JV10-NL Block Diagram

Project code: 91.4HX01.001
 PCB P/N : 48.4HX01.0SB
 REVISION : SB

SJV10-NL			
緯創資通		Wistron Corporation 21F, 88, Sec.1, Hsin Tai Wu Rd., Hstchih, Taipei Hsien 221, Taiwan, R.O.C.	
Modify History			
Size A3	Document Number	SJV10-NL	Rev -1
Date:	Sunday, January 31, 2010	Sheet 42	of 42

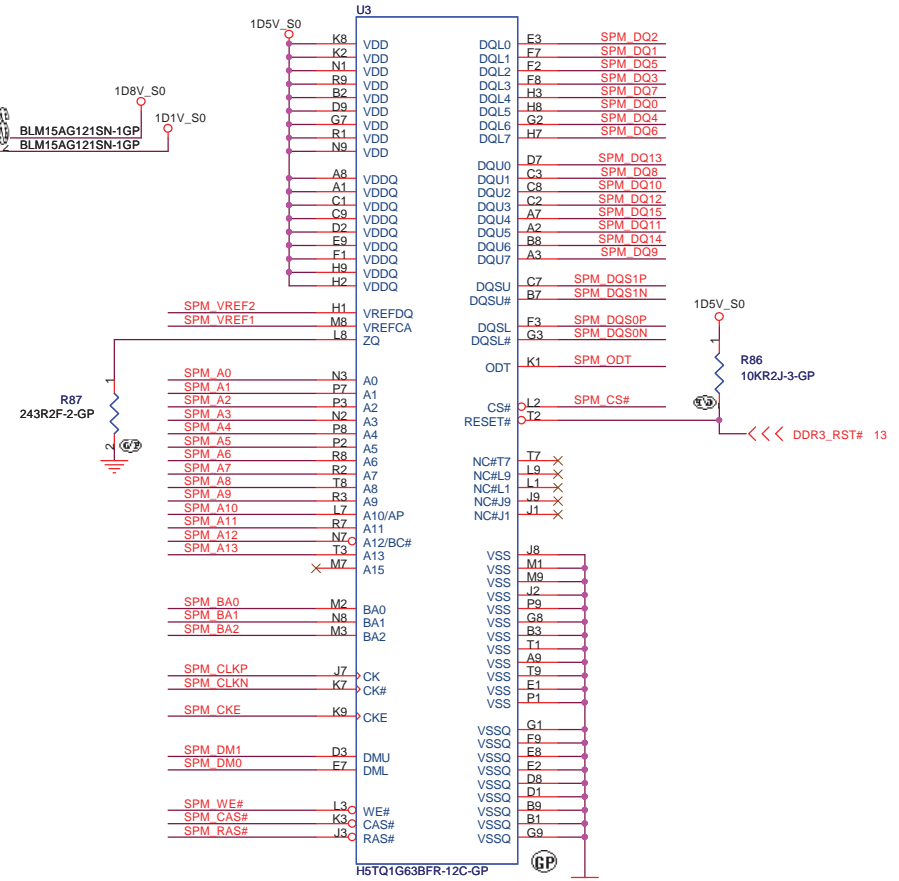
-1 Change R76,R78 to RN138.

-1 Change R77,R79 to RN139.

Title: **ATI-SB820M USB&GPIO (2/5)**

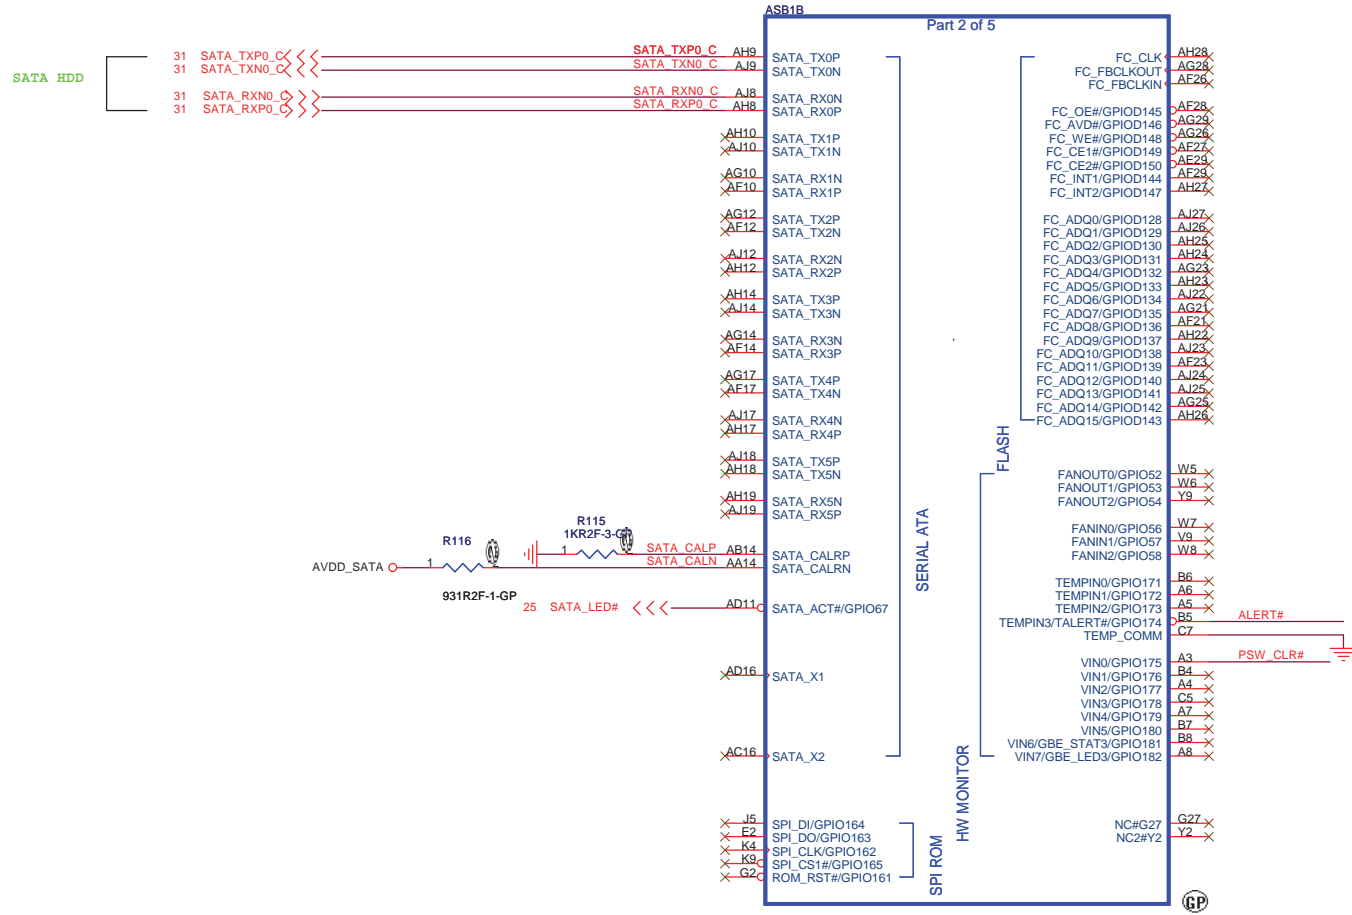
SB Change S5_PWR_GD pull high
from R261 to RN43.

Title LCD Conn

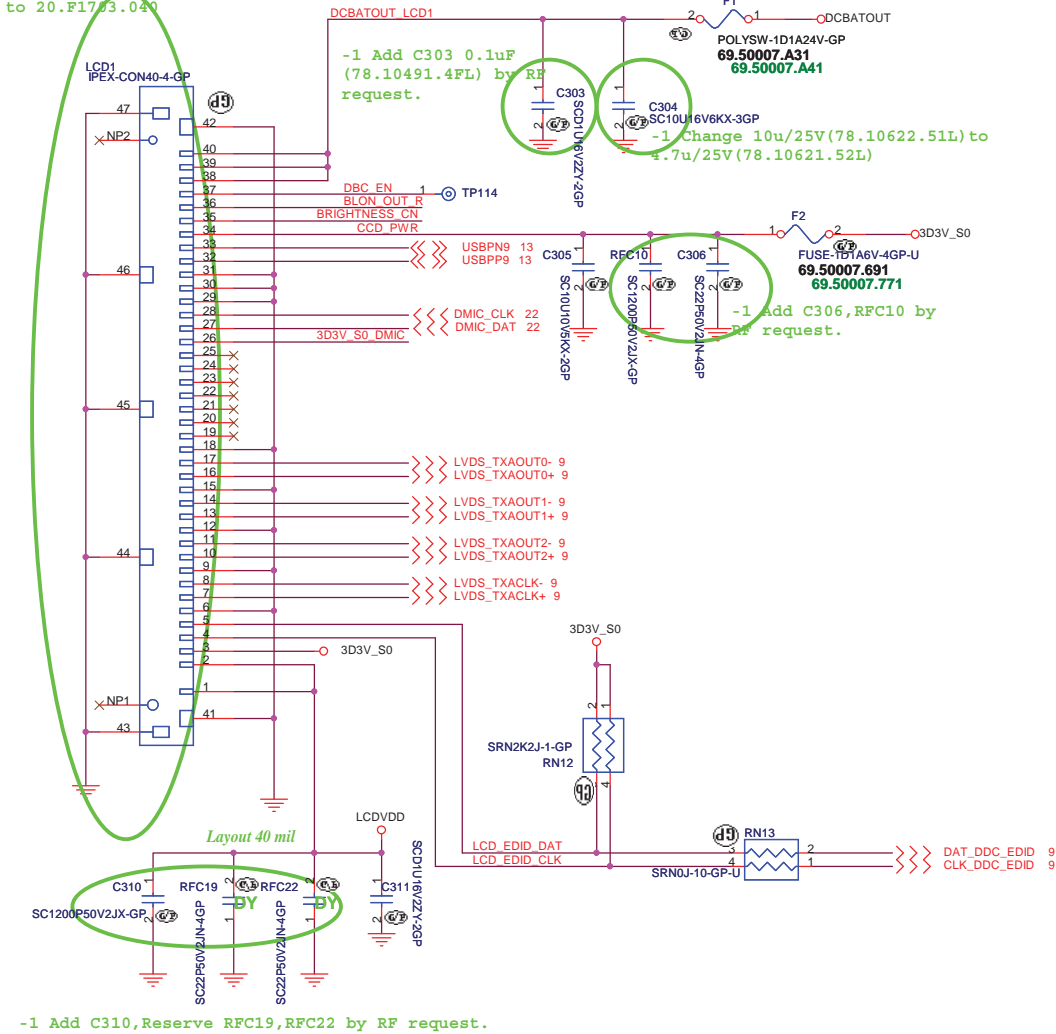
SB Change P/N from 20.F1093.040 to 20.F1703.040

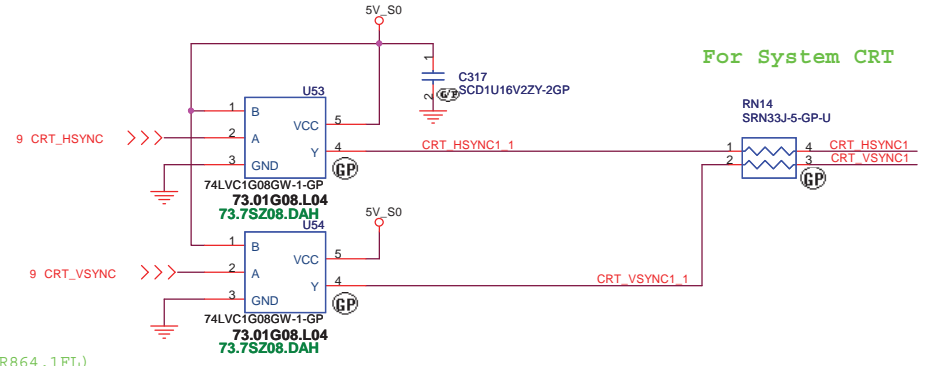
SB Change R859 from 150 ohm to 140 ohm

SB change capacity from 6.8pF (78.6R864.1FL) to 5.6pF (78.5R674.1FL)

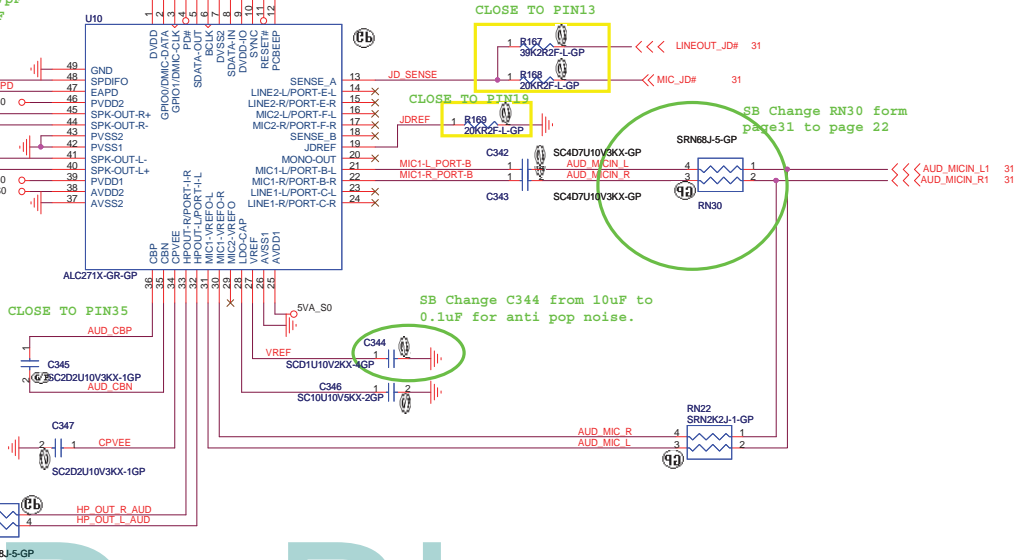
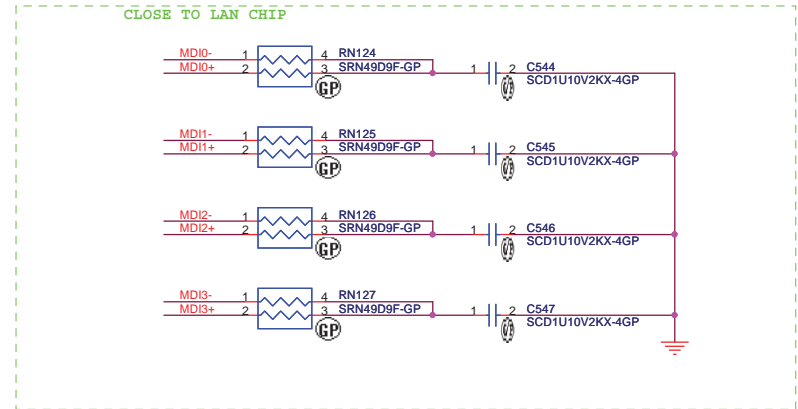
13 ACZ_SDATAIN0 <<< R165 10R2J-2-GP
 13 ACZ_BITCLK_AUDIO >>>
 13 ACZ_SDATAOUT_AUDIO >>>
 -1 Change R166 to reserved D21.

1 Add R335, EC74-EC79 for AGND connect.

SB Change C344 from 10uF to 0.1uF for anti pop noise.

-1 Add reserved R875, change pull high to 3D3V_S5.

SB 2nd source change from 82.30005.C51 to 82.30020.A31
Change C540 from 27pF to 18pF
Change C541 from 27pF to 45pF

-1 Change C541 to 18pF.

SJVV10-NL		緯創資通 Wistron Corporation 21F, 88, Sec.1, Hsin Tai Wu Rd., Hstchih, Taipei Hsien 221, Taiwan, R.O.C.	
Title RUN AND AUX POWER			
Size A3	Document Number	Rev	-1
Date: Sunday, January 31, 2010		Sheet 27	of 42

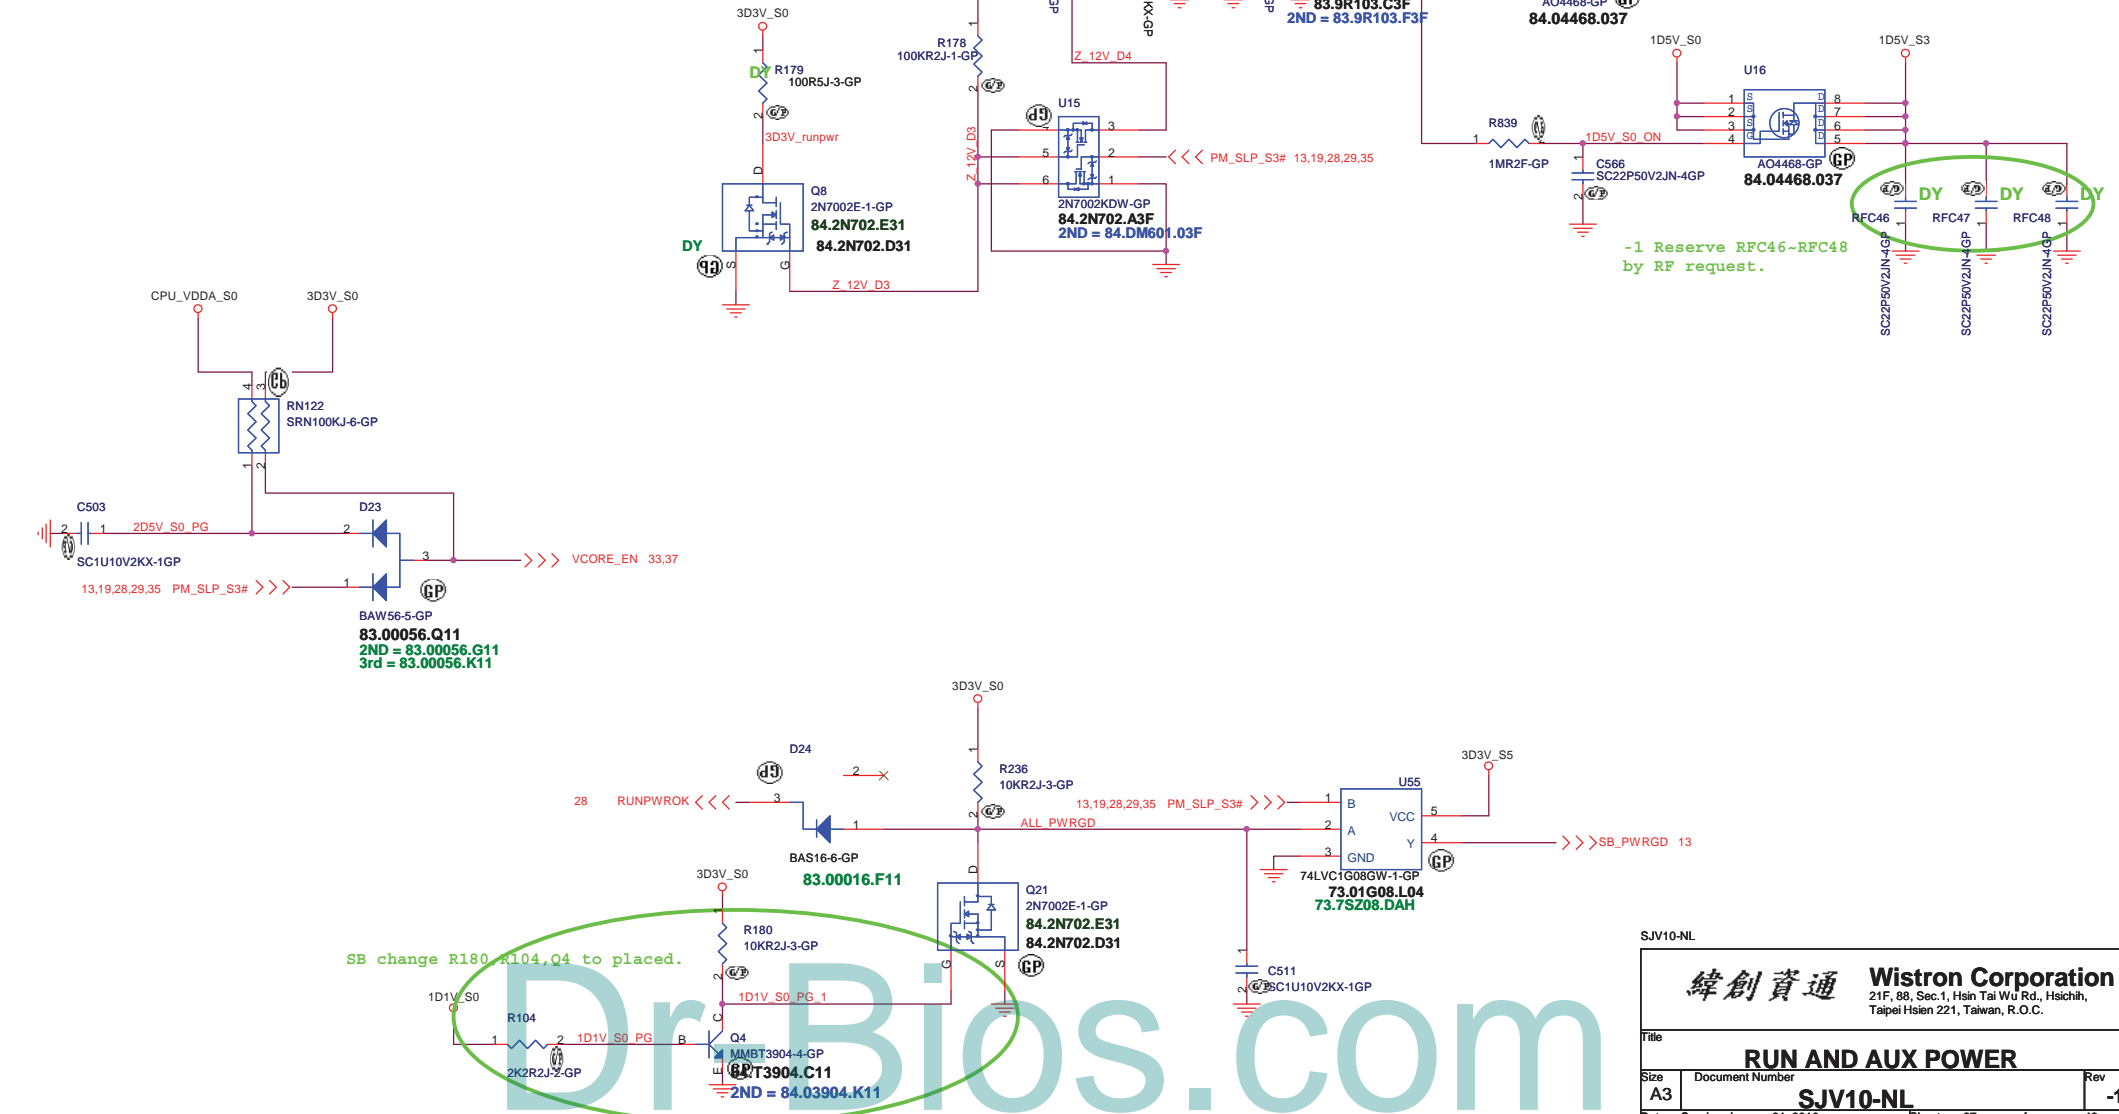
SB change R180, R104, Q4 to placed.

Title: **KBC NPCE781B**

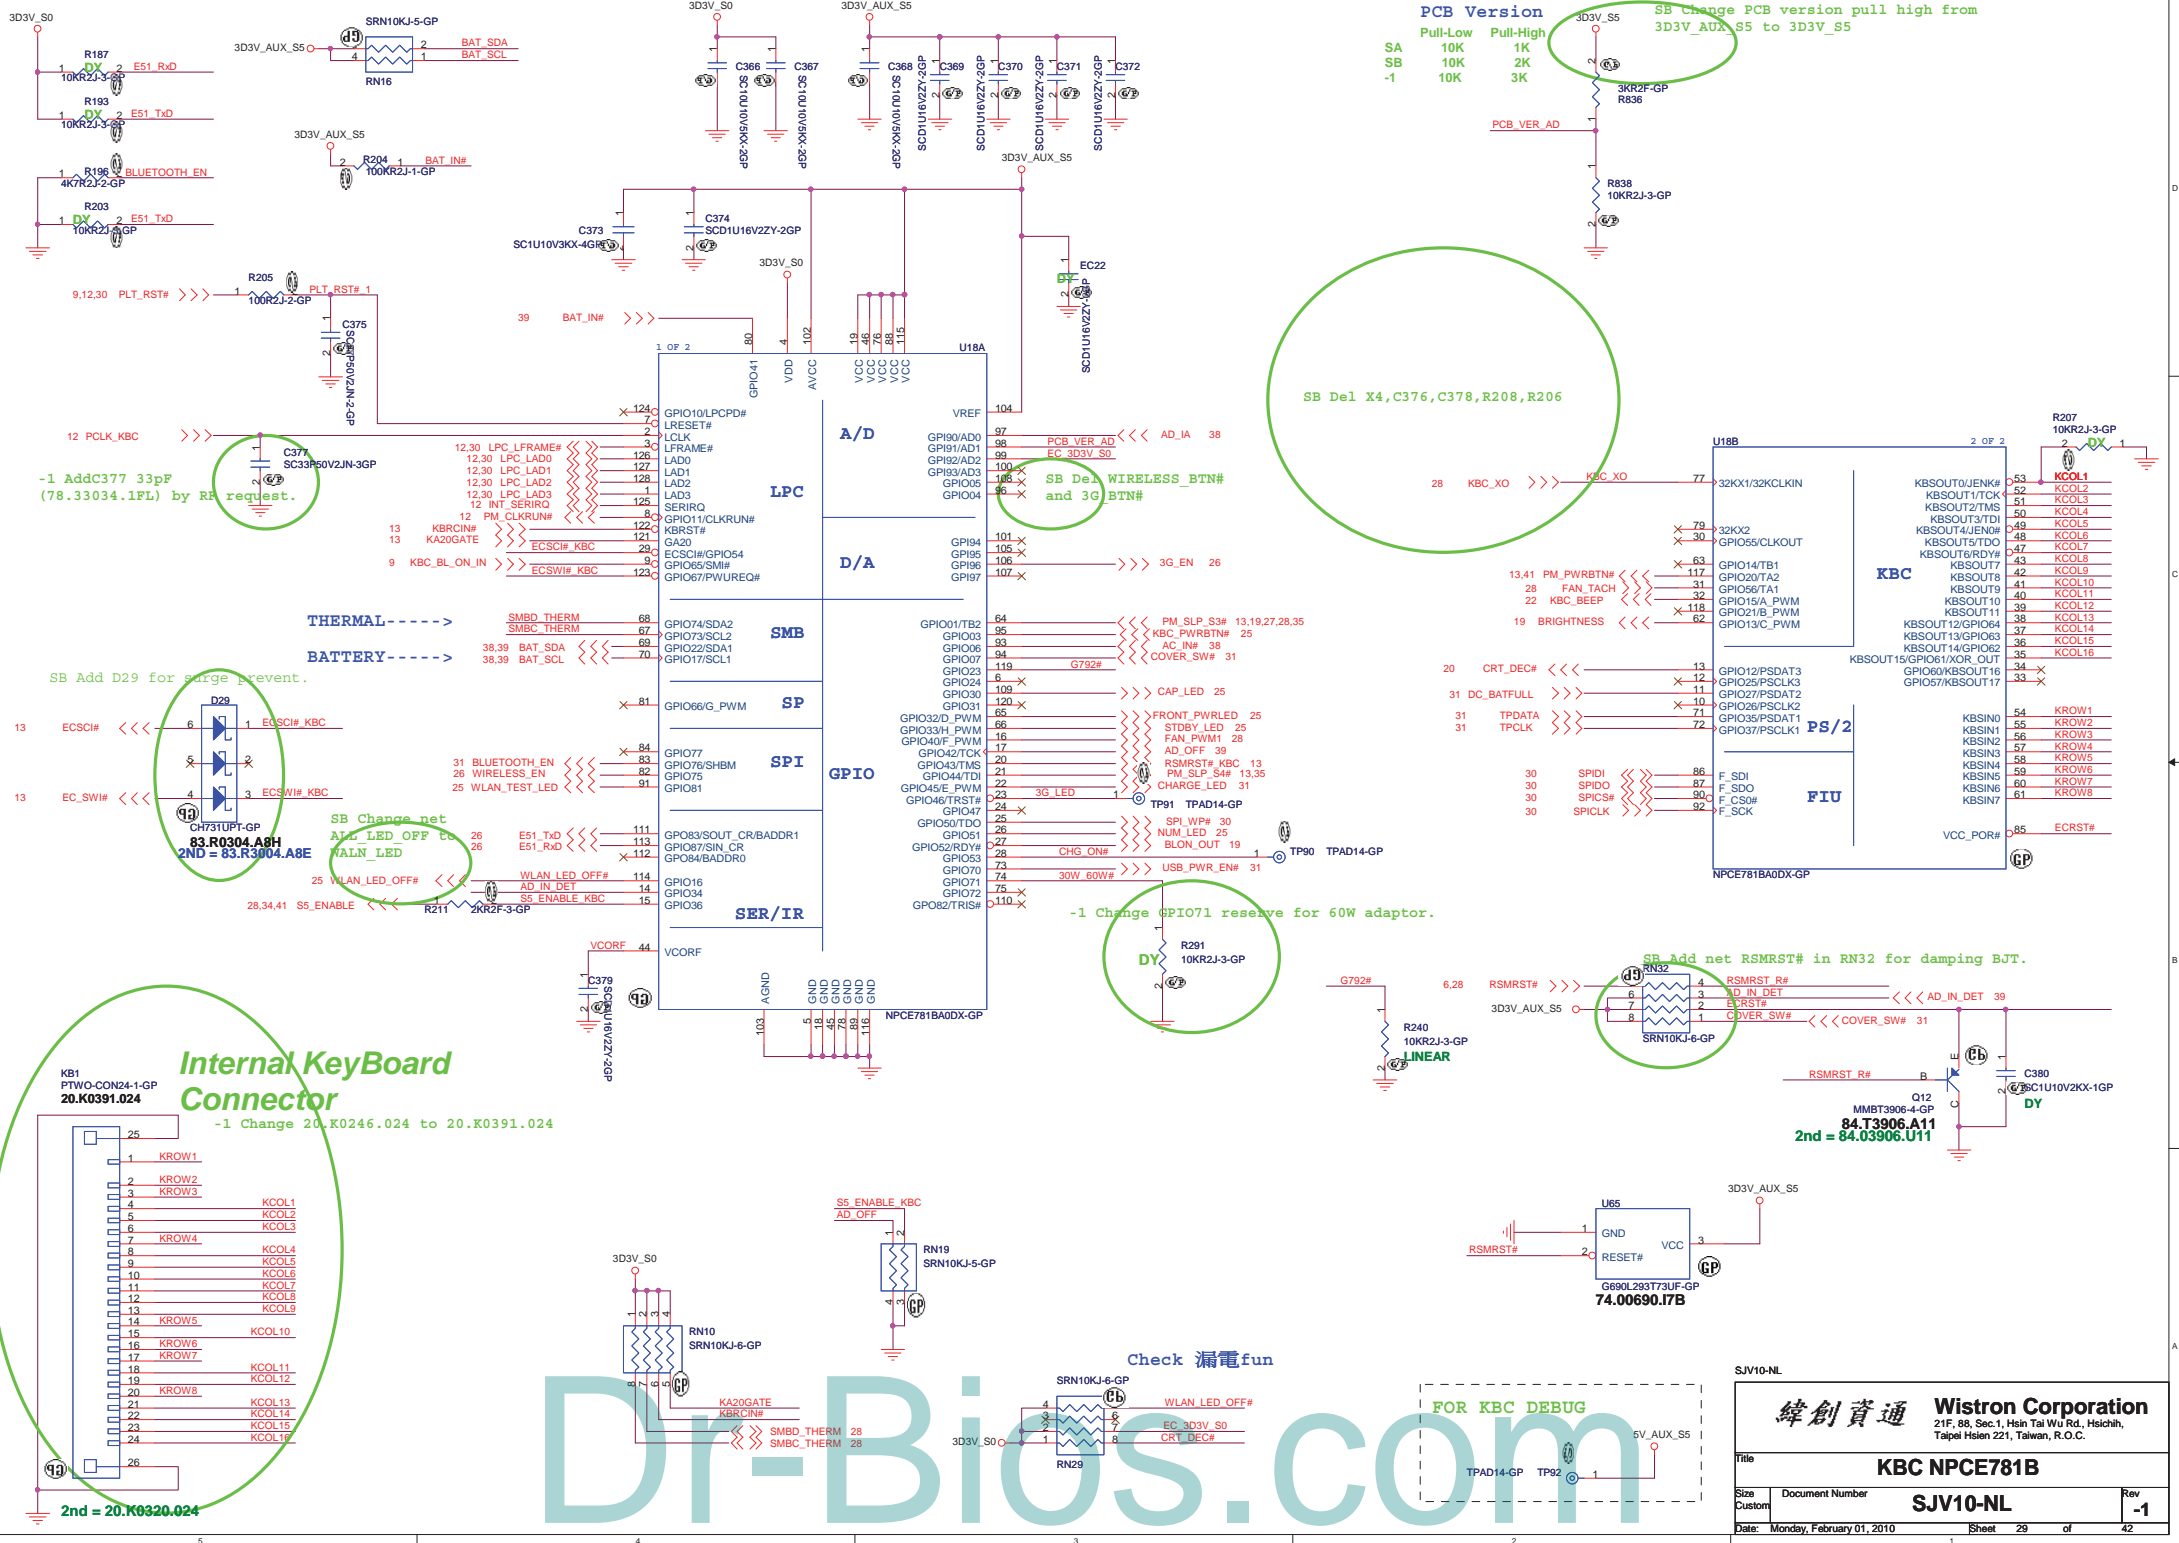
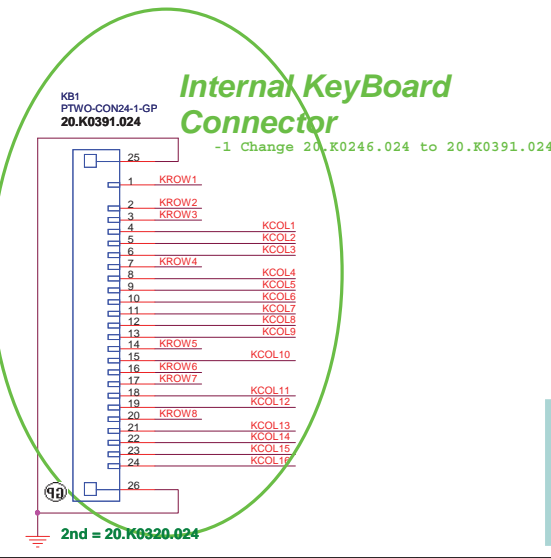
SB Change PCB version pull high from 3D3V_AUX_S5 to 3D3V_S5

SB Del X4, C376, C378, R208, R206

SB Del WIRELESS_BTN# and 3G_BTN#

-1 Add C377 33pF (78.33034.1FL) by RF request.

SB Add D29 for surge prevent.

SB Change net ALN_LED_OFF to WLAN_LED

-1 Change GPIO71 reserve for 60W adaptor.

SB Add net RSMRST# in RN32 for damping BUT.
